HEFLIN POLICE STATION
850 Ross Street
Heflin, Alabama

ADDENDUM NUMBER THREE

January 9, 2026

6 BREAK ROOM B207
1/2"=1'-0"

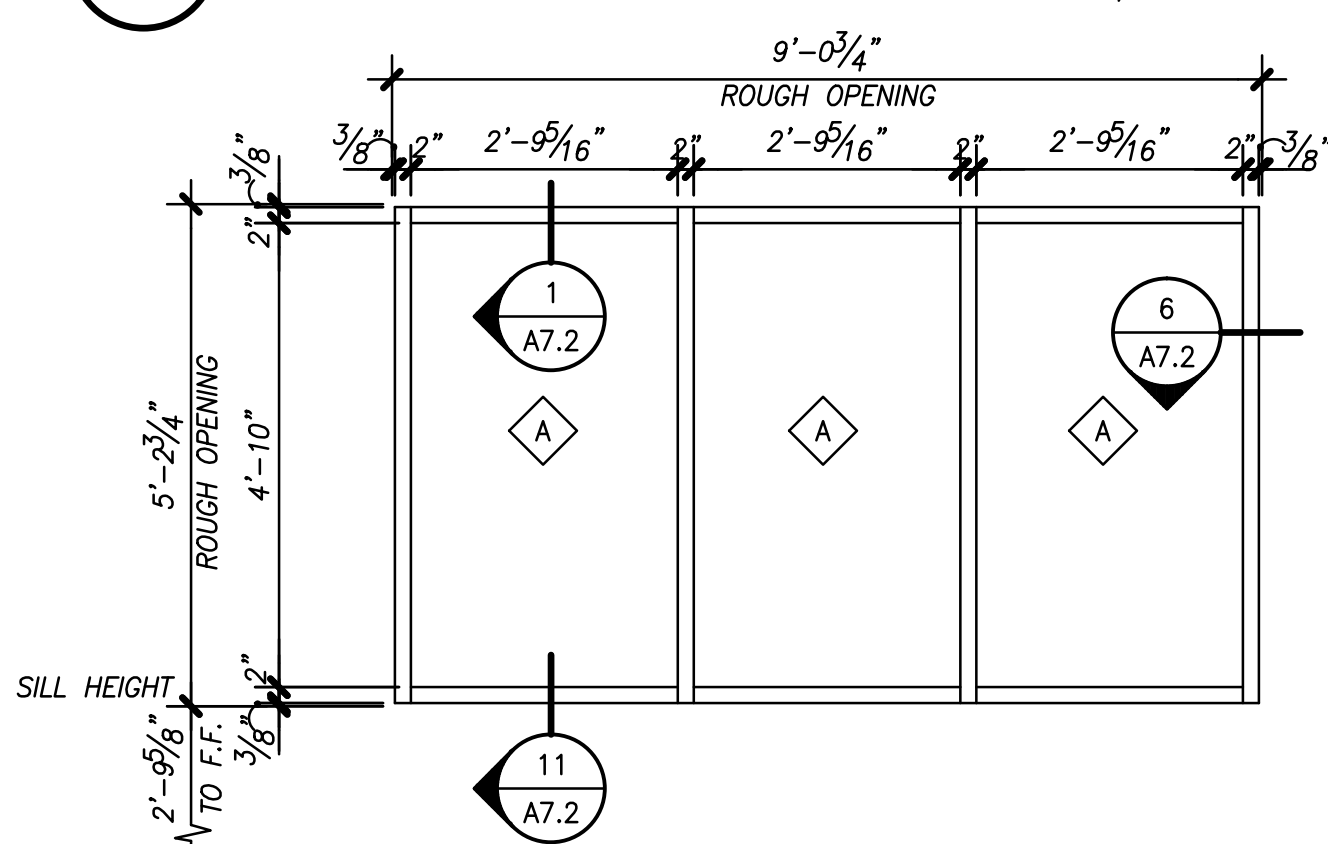
7. Replace A4.1 with the attached A4.1 revised January 9, 2026 to indicate modified storefront at the North Elevation.
8. Replace A4.2 with the attached A4.2 revised January 9, 2026 to indicate modified storefront at the North Elevation.

SECTION 1 @ ENTRANCE

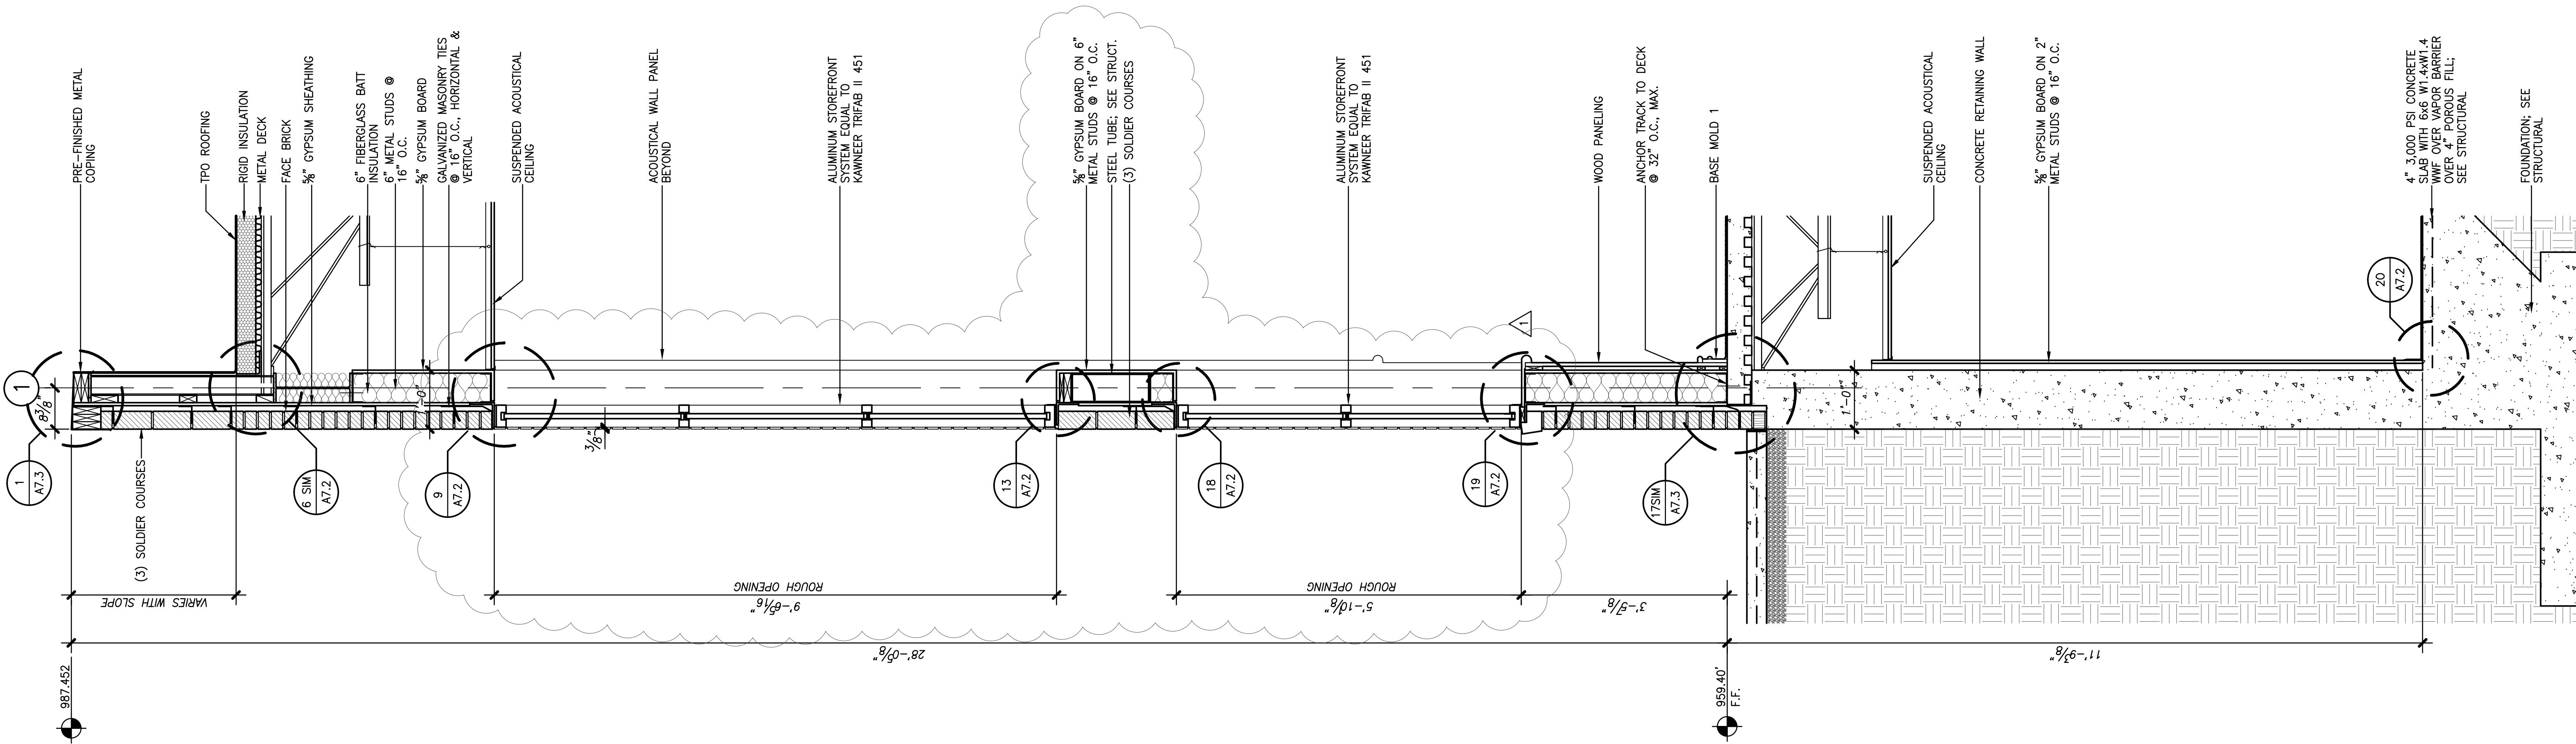
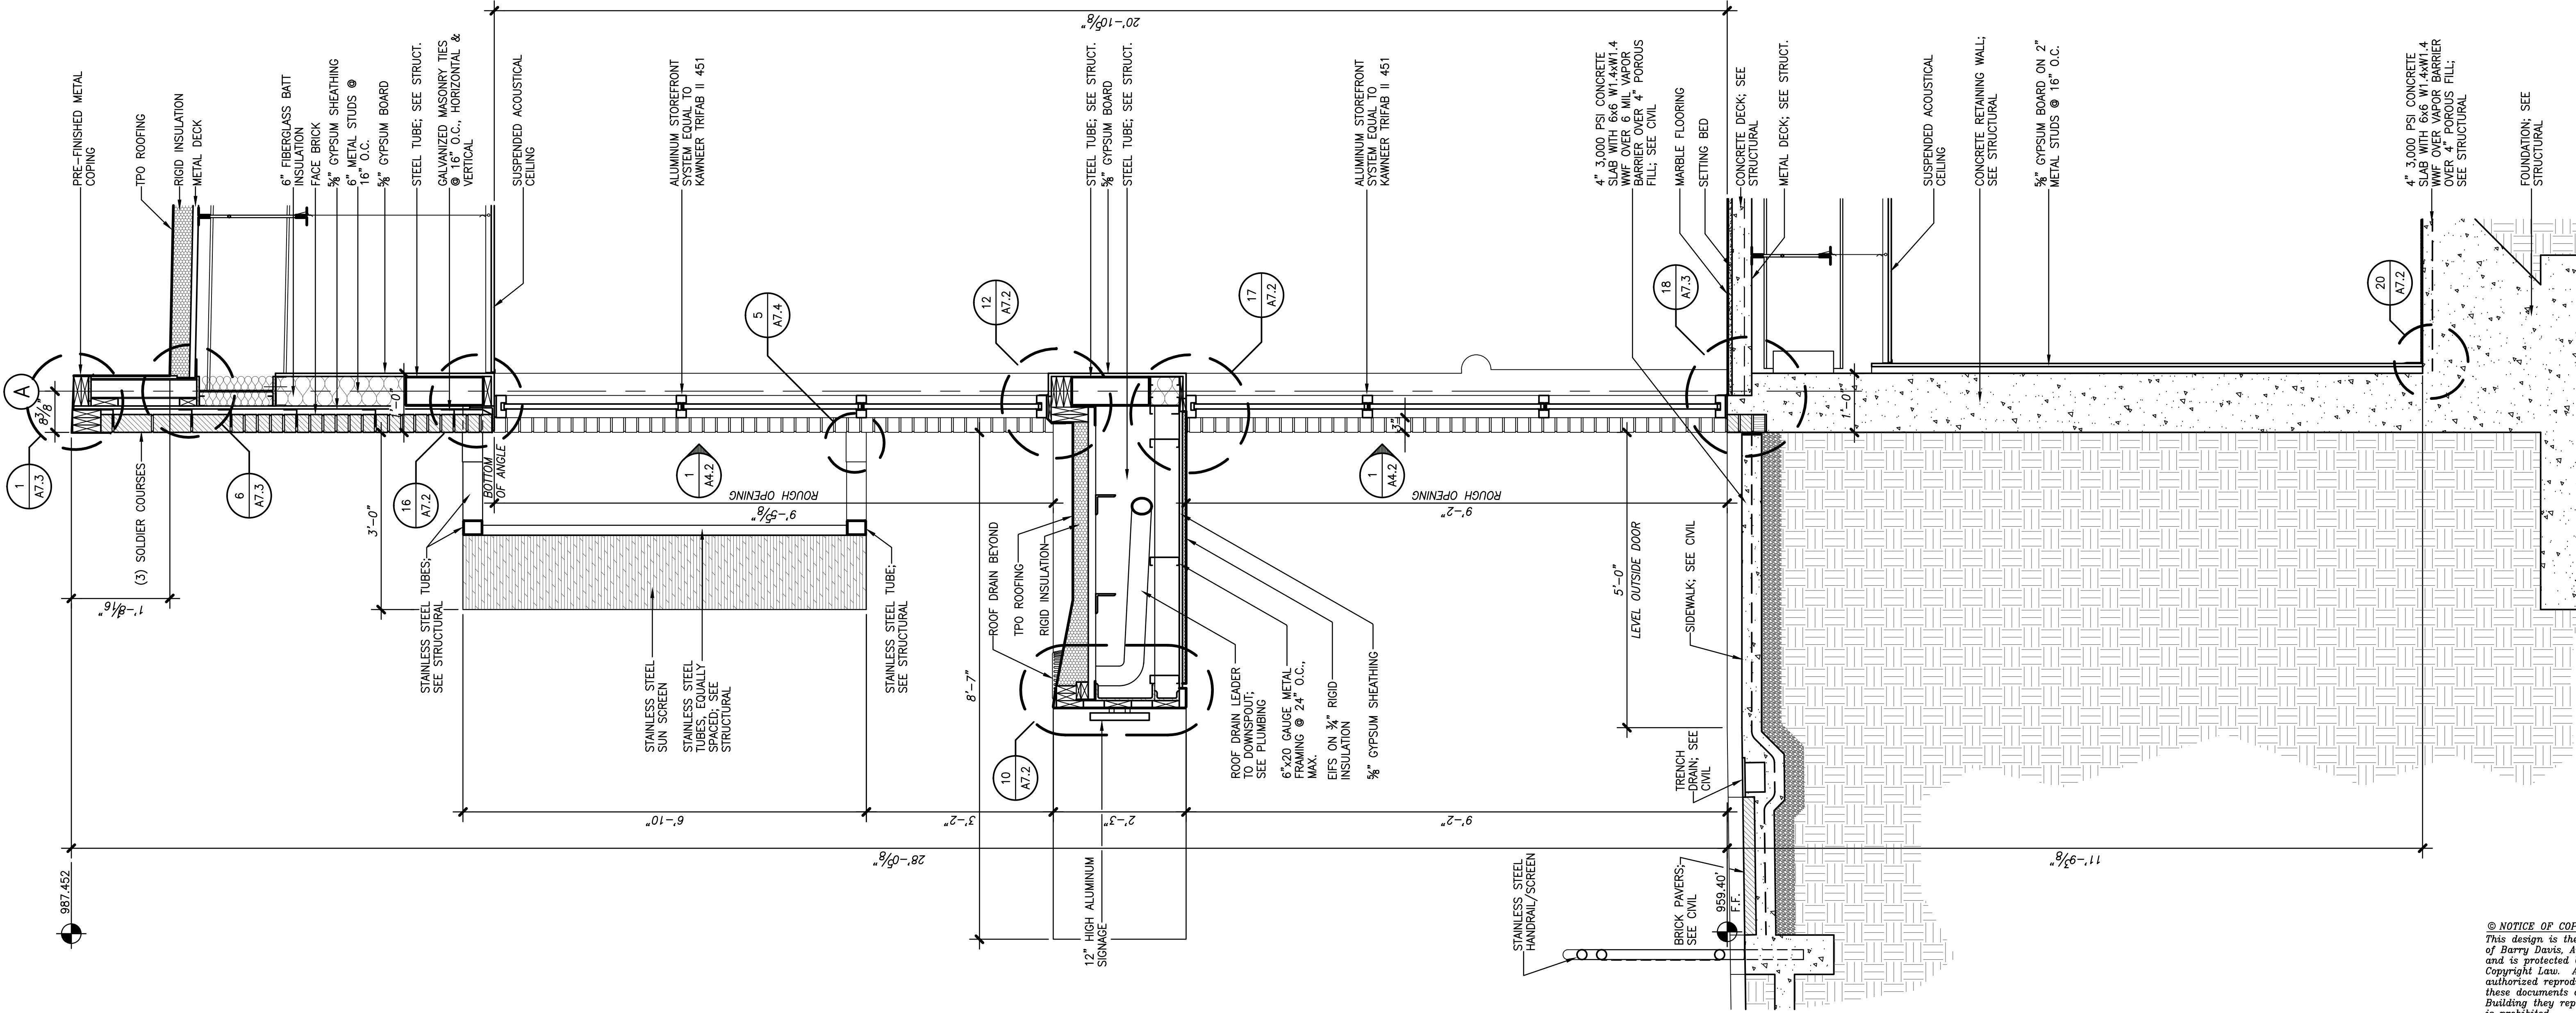
9. Replace A6.3 with the attached A6.3 revised January 9, 2026 to indicate modified storefront at the North Elevation.
10. Replace A7.2 with the attached A7.2 revised January 9, 2026 to indicate modified storefront at the North Elevation.
